APPROVED MINUTES OF THE MEETING

February 19, 2009

Rose Street – Wolcott Ave. S
Seattle Trade Center Skybridge over Elliott
SR 519 Phase II Grade Separation
University of Washington Light Rail Station

Northerly view of the Light Rail Station Improvements

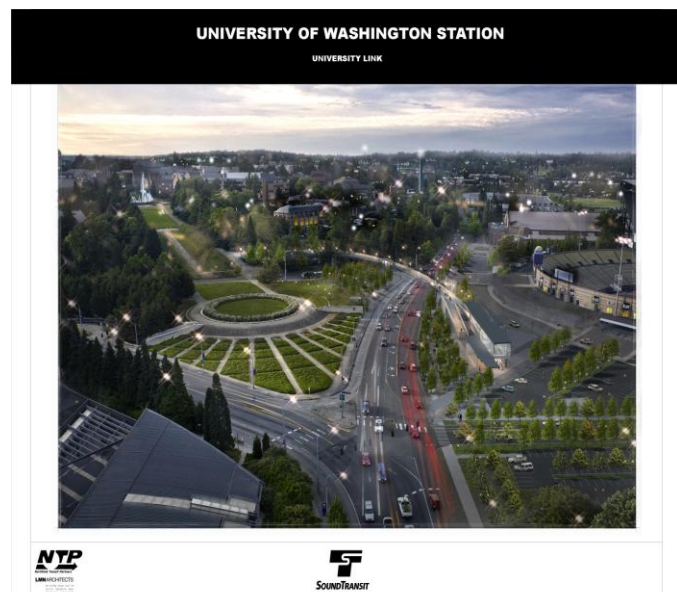
Very excited about the art, beautiful piece, but it should inform the architecture more. It would be nice to borrow some of the inspiration from the art for the architecture. The dark tiles seem somber and clash with the light and more vibrant artwork. Open to comments.

Appreciates the care of the architecture, but more opportunity for energy between the art and architecture. The ribbon handrail is elegant, but durability is a question. The structural chamber, is the engineer done? The somber tone of the tile feels a little heavy.
